Draft Greater Geelong Planning Scheme
Amendment C450ggee
Creamery Road Precinct Structure Plan and
Development Contributions Plan

**Northern and Western Geelong Growth Areas Standing Advisory Committee
Referral 2 Report – Volume 1**

1 July 2026

Figure 1 Council's Final Future Urban Structure Plan for the precinct

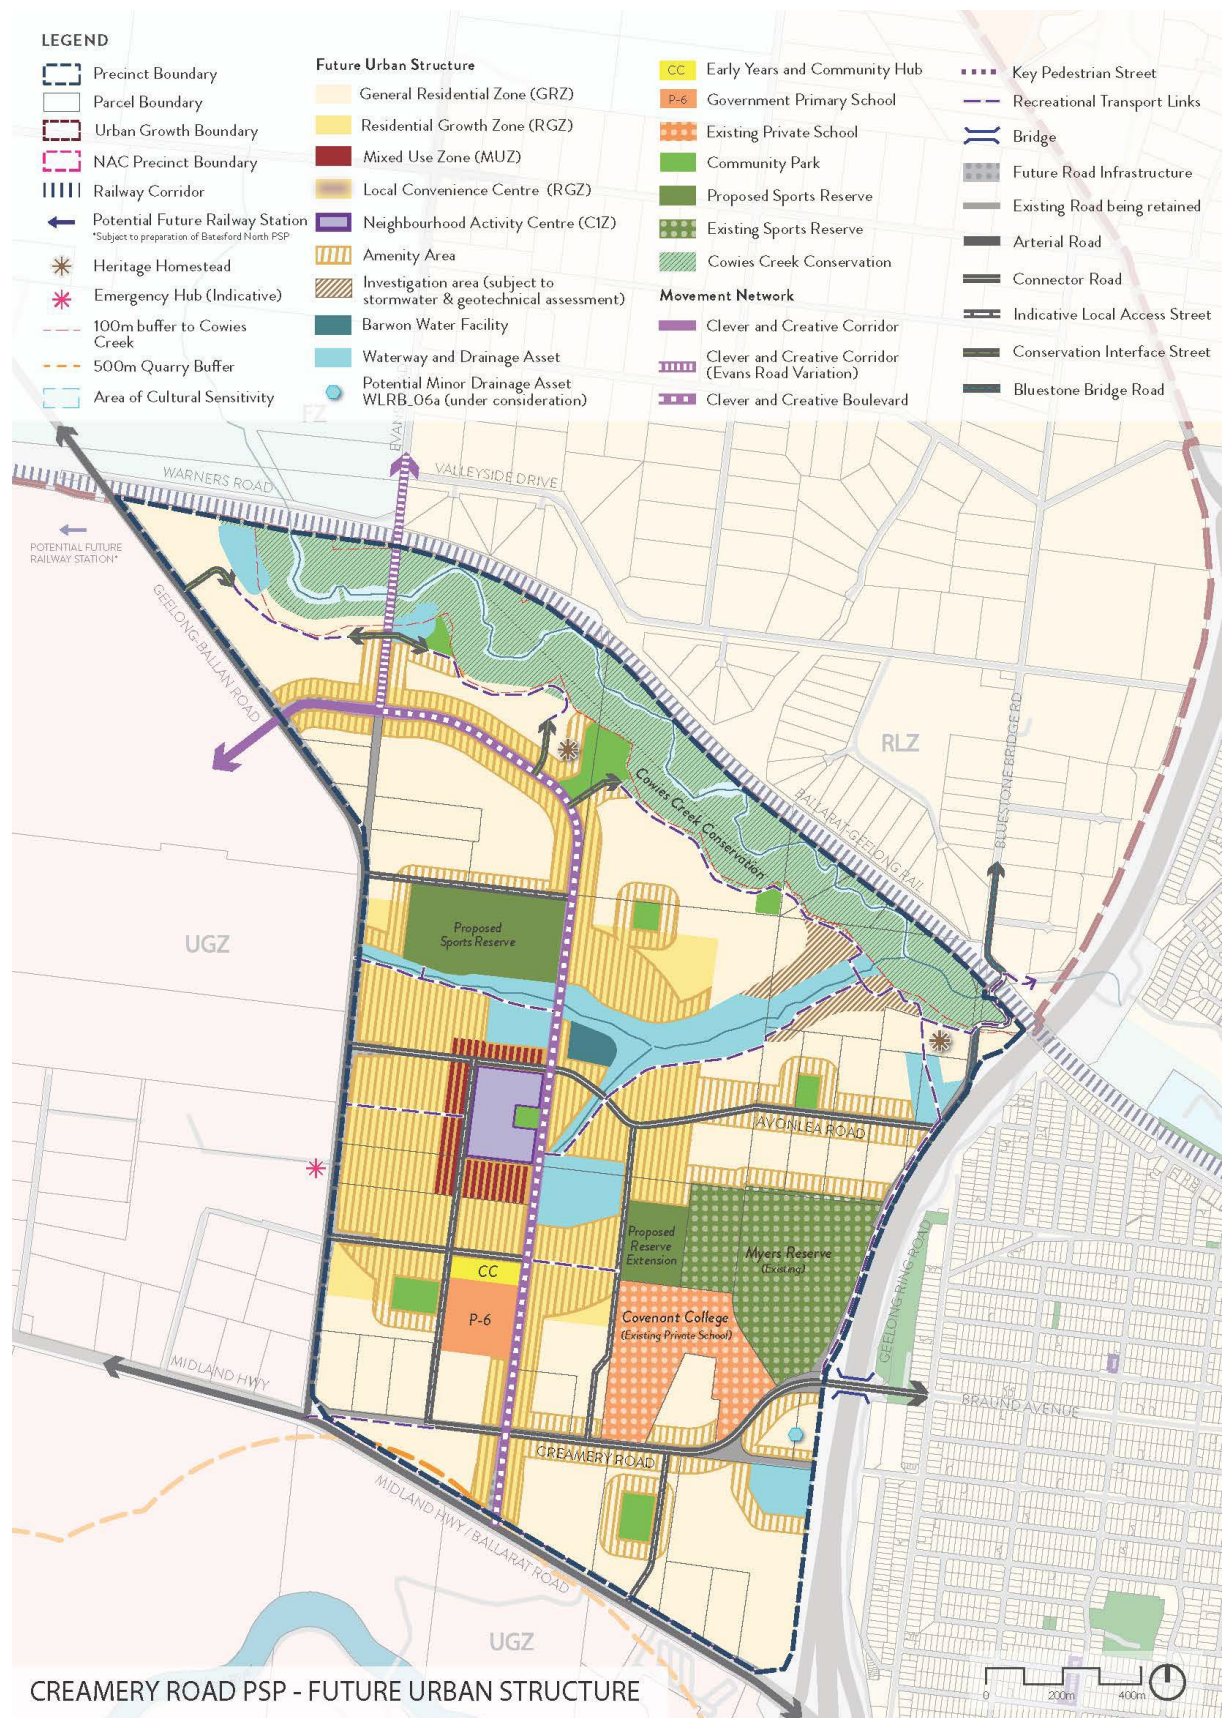
The Committee supports the location and size of the NAC as shown on Council's Final Future Urban Structure Plan. The NAC should be located on the corner of the east-west connector road and the Clever and Creative Boulevard (CCB) and have an area of 4 hectares. This location will meet the broader strategic objectives for the precinct and best serve the needs of future communities within the precinct.

The Committee found that the size, configuration and location of Basin 6 and Basin 7 as shown on the Council's Final Future Urban Structure Plan is appropriate.

It is appropriate to accommodate a split basin arrangement at Basin 6, however no change is required on the Future Urban Structure Plan.

Basin 7 can be redesigned as a sediment basin to reduce the size and cost of the asset. This may result in a change to the Future Urban Structure Plan – but the nature of the

change will need to be confirmed once the design is settled, as such no change to the Future Urban Structure Plan at this time.

- 1. Amend the Final Creamery Road Future Urban Structure Plan (Document 126) as follows:**
 - a) Show the northern and southern Local Convenience Centres in the locations on the Exhibited Future Urban Structure Plan, and at a size of 1,000 square metres each.**

- b) Retain Community Parks 6 and 7 as one-hectare parks.**
 - c) Show a 'potential' left-in/left-out intersection on Midland Highway between Geelong Ballan Road and the Clever and Creative Boulevard, with an access street extending north to Creamery Road.**

- f) Delete the red line described as '100-metre buffer to Cowies Creek'.**

Figure 6 Villawood alternative Future Urban Structure Plan (Villawood Plan)

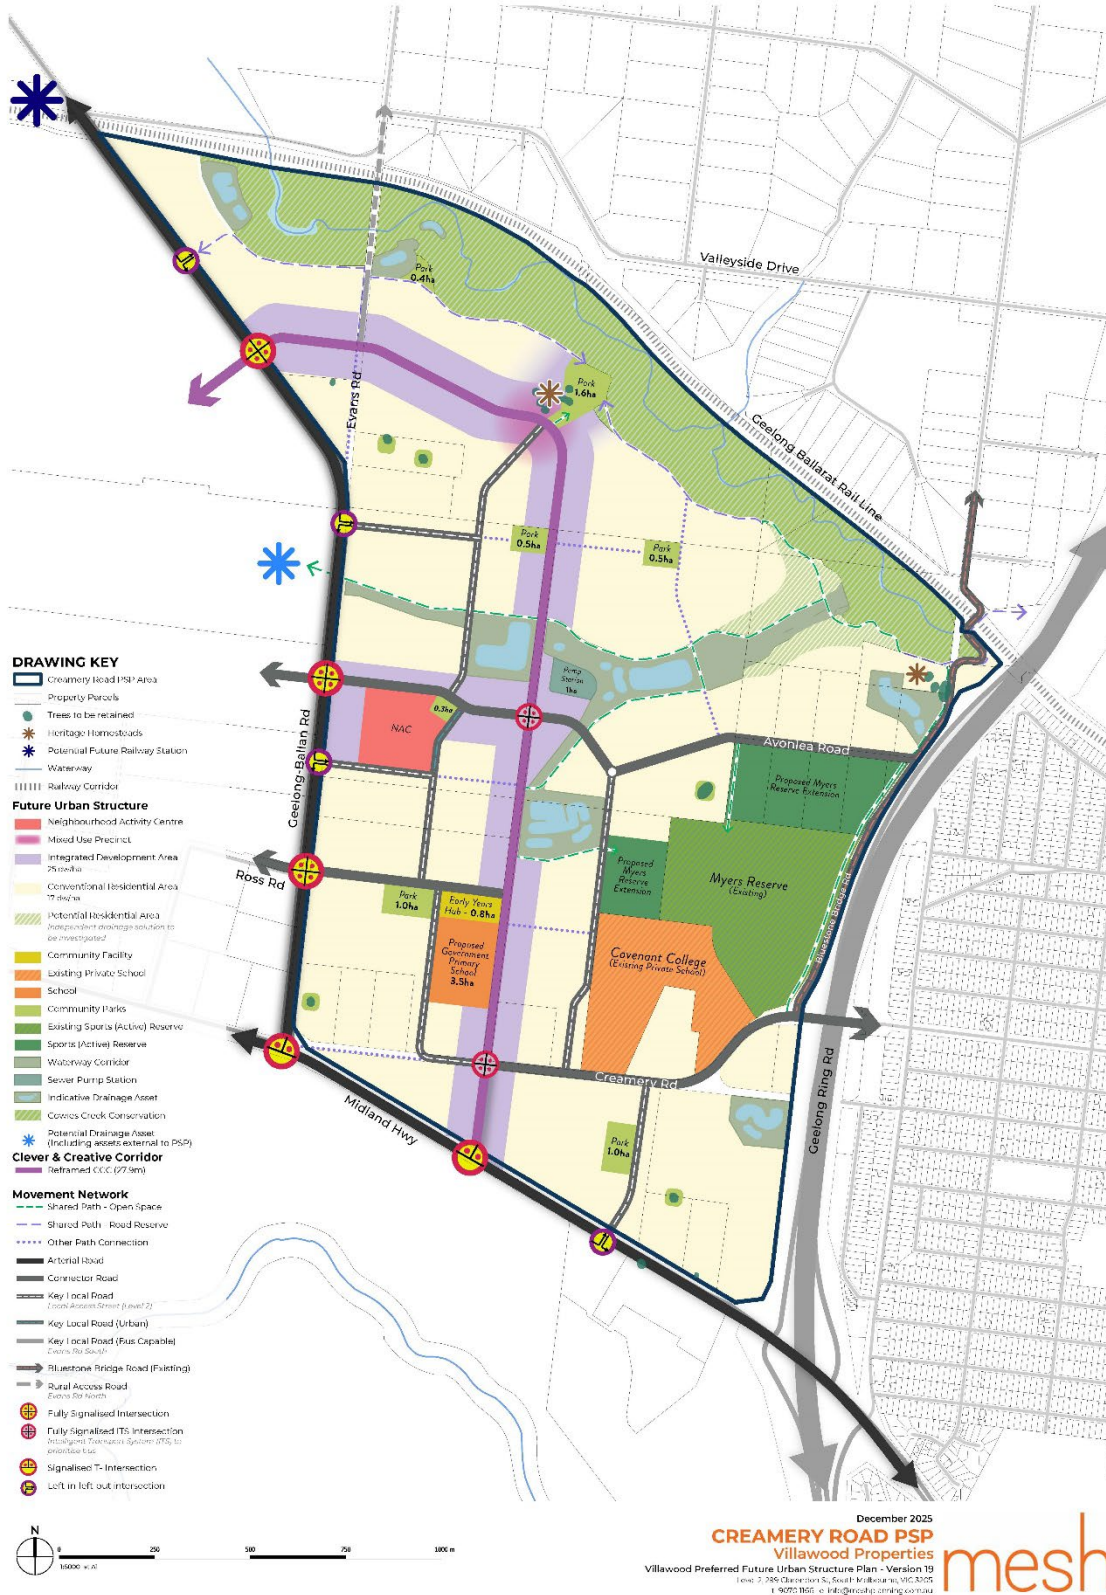
Villawood submitted the Villawood Plan (Figure 6) shows a redistribution of community parks as a result of the proposed relocation of the Reserve 2 to a northern extension of Myers Reserve, which meets the catchment targets in the PSP Guidelines.

Figure 8 Villawood preferred NAC location

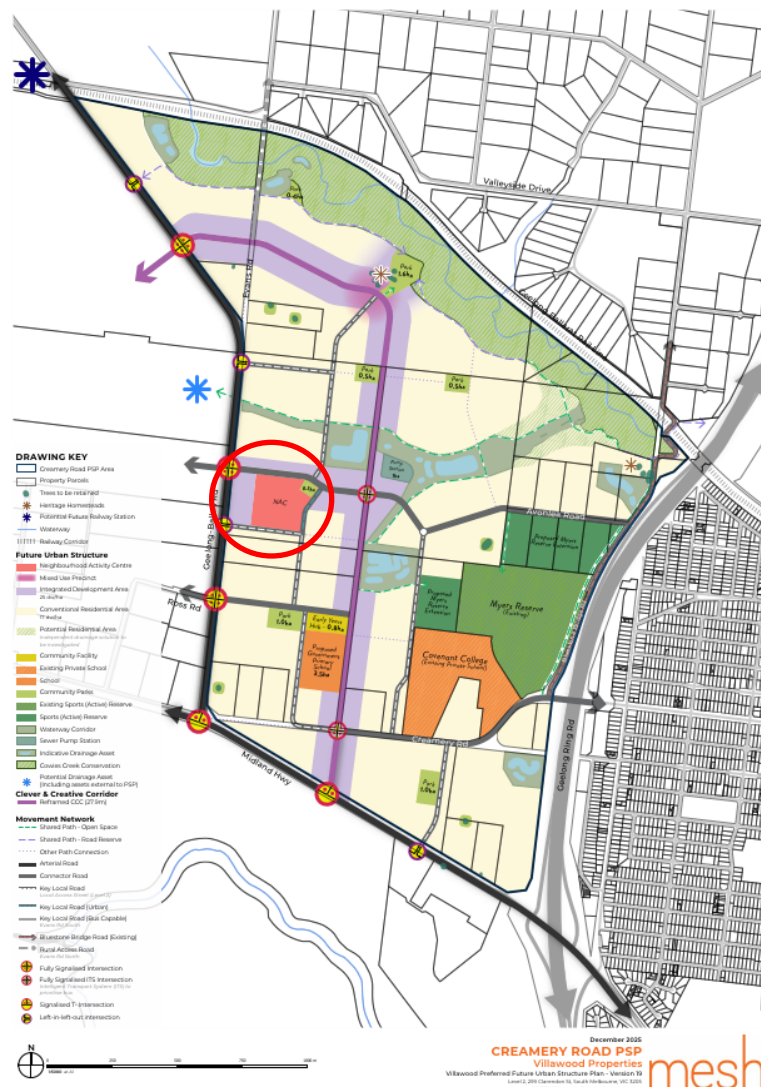
Villawood’s proposed alternative Future Urban Structure Plan (the Villawood Plan, Figure 8) shows the NAC located 200 metres to the west, in between the CCB and Geelong-Ballan Road.

Figure 9 LCCs in the Exhibited Future Urban Structure Plan

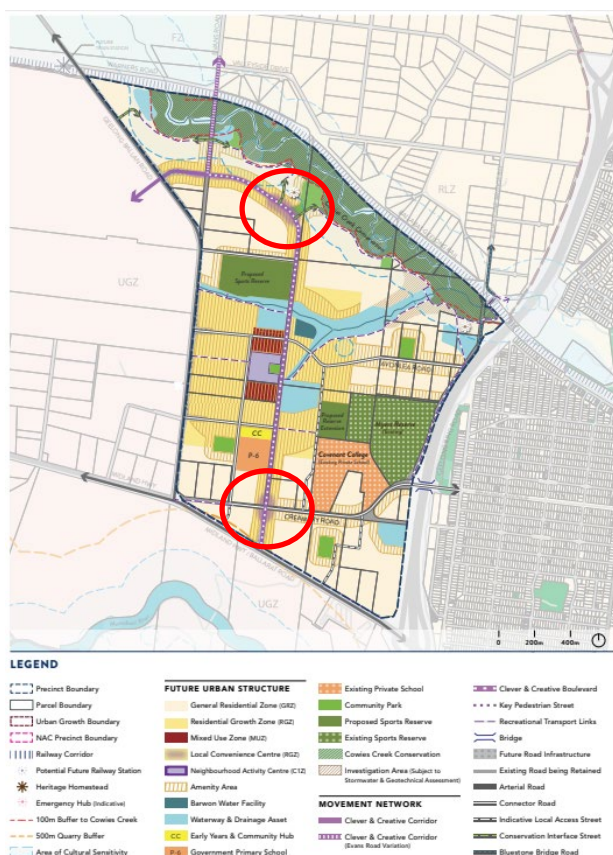
The Exhibited Future Urban Structure Plan showed two LCCs.

Figure 16 Final Future Urban Structure Plan – Transport network issues

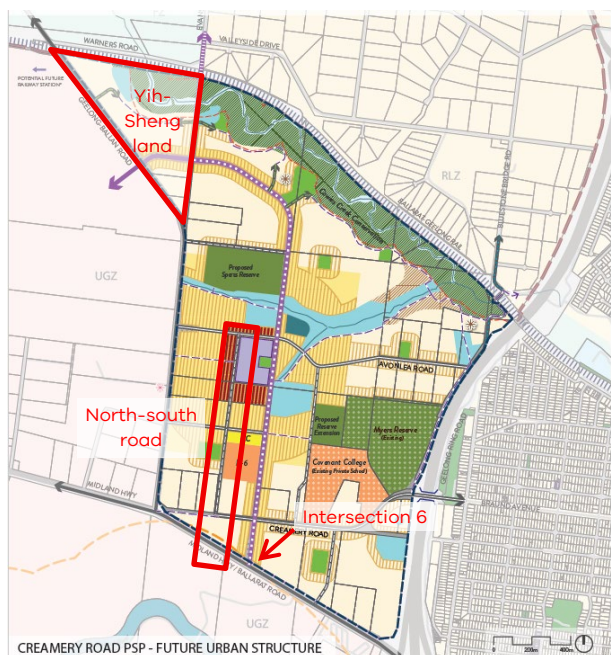
In its Final Future Urban Structure Plan, Council changed the north-south road to an access street to the north of Creamery Road and deleted the section to the south of Creamery Road (see Figure 16).

Figure 18 Plan included in EPBC Act approval for Yih-Sheng land

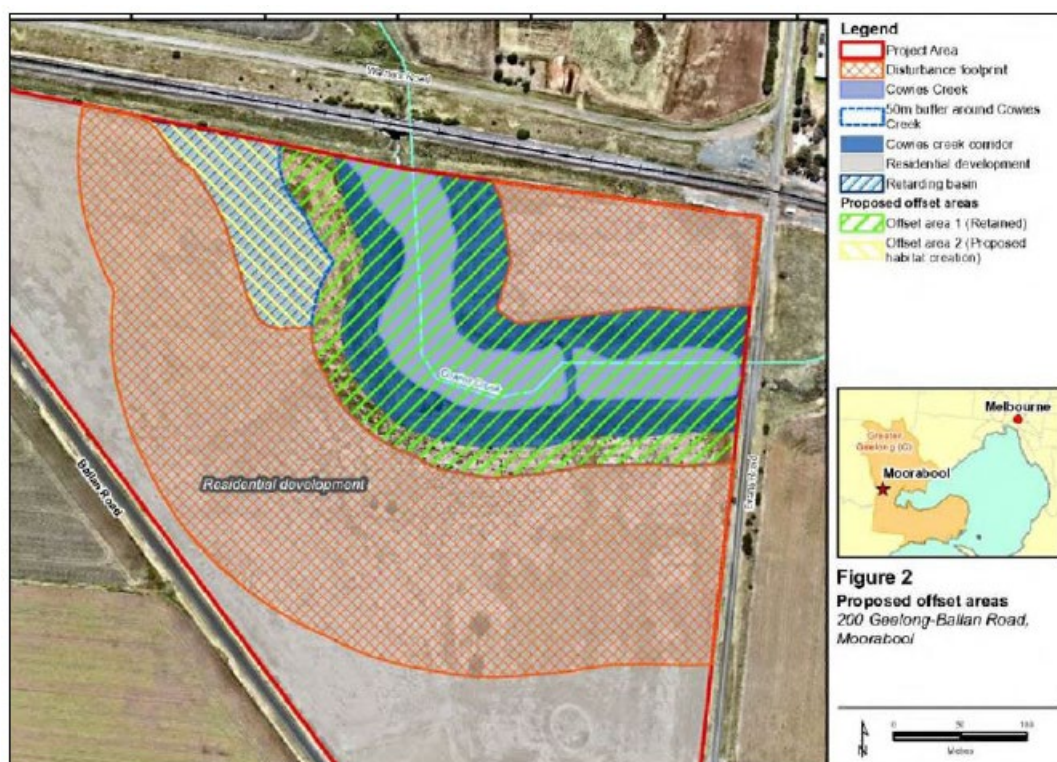
A site-specific Part 9 EPBC Act approval was granted for the land at 200 Geelong-Ballan Road, Moorabool (Yih-Sheng land). The EPBC Act approval allows a 50-metre buffer along Cowies Creek (measured from the centreline of the creek, as shown in Figure 18), a distance that is inconsistent with the 100-metre buffer proposed more generally across the precinct. The EPBC Act approval includes other conditions.

On the Yih-Sheng land, the Committee supports a narrower buffer to the south of Cowies Creek, generally aligning with the EPBC Act approval for that land. The Committee does not support a change to the buffer to the north of Cowies Creek. Based on the information currently available, it would be premature to designate the land in the north-eastern corner of the Yih-Sheng land as developable. However, the Committee recommends the Future Urban Structure Plans should identify this as an area for further investigation.

Figure 19 Creek buffer extent as shown in Council's Final Future Urban Structure Plan

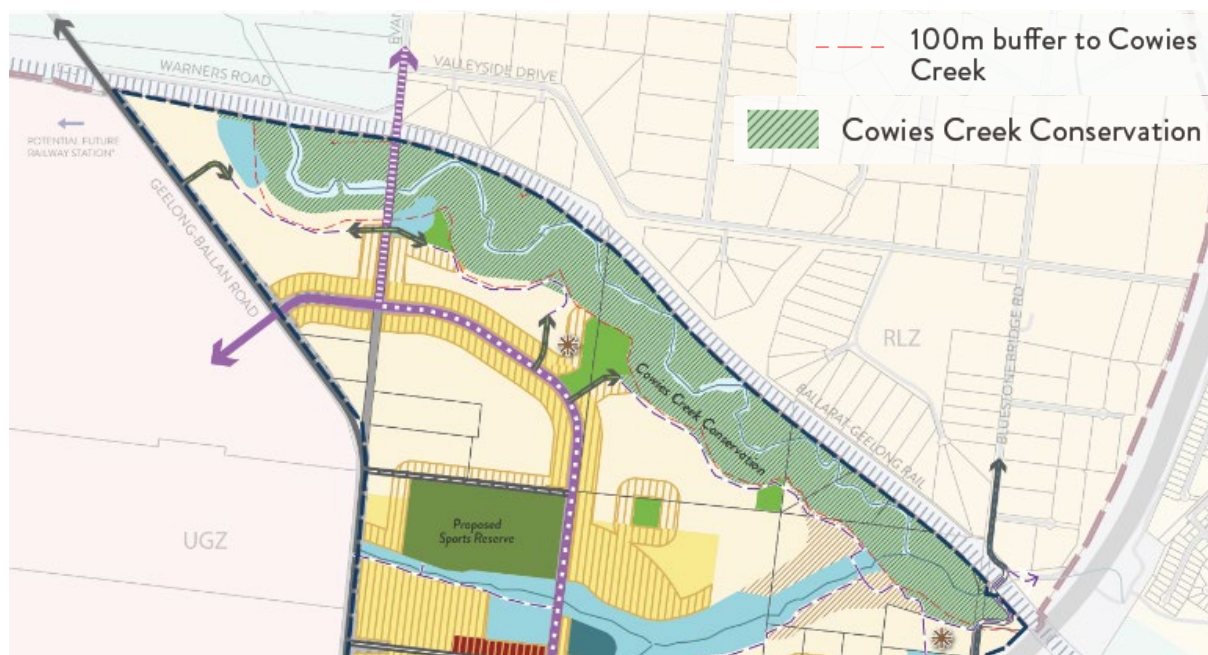
- The 100-metre buffer line (red line) on the Future Urban Structure Plan should be retained as it is indicative only.
- Basin 8 should not encroach on EPBC Act offset area 2 and should not be resized, as micro siting and sizing are matters for detailed design.
- Its final position on the creek buffer extent is reflected in the Final Future Urban Structure Plan shown in Figure 19.

Figure 9-1: Indicative minimising of BR 01 length of bridge

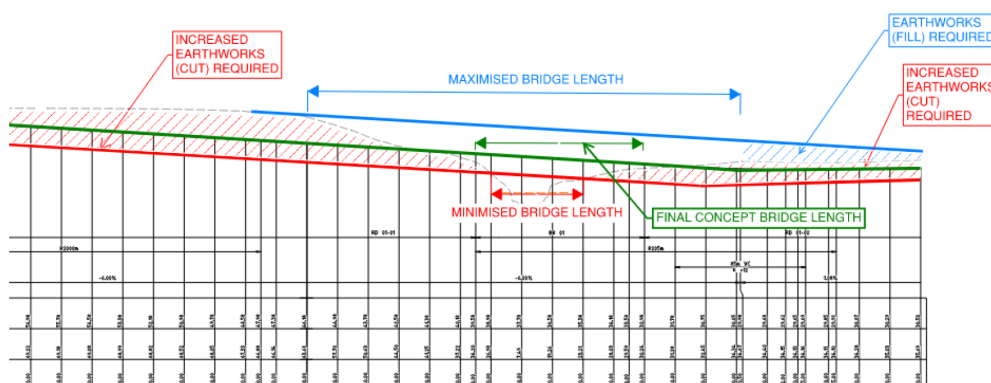
This approach, as outlined in Section 6.8, has resulted in one of the approaches, the northern approach to bridge BR-01, requiring a significant amount (when compared to all other approaches) of cut / earthworks below the existing surface to tie the road into the proposed bridge location, as shown through the green line in Figure 9-1 (alternative options that minimize the earthworks or bridge are also shown in Figure 9-1, as the blue and red dashed lines, respectively).

With reference to the Figure 9-1 above, the level of cut for the northern approach to bridge BR-01 (which was adjusted to 516m through the design process) accounts for the majority of the required earth works prior to where the road adopts a level of cut closer to the average 1,000 cubic meters of cut per meter.

- b) Update the project costings for Bridge 1 in accordance with the revised costings prepared under Recommendation 3(d).**
- c) Update any other project costings to account for any other consequential changes arising from the Committee's recommendations in this Report.**
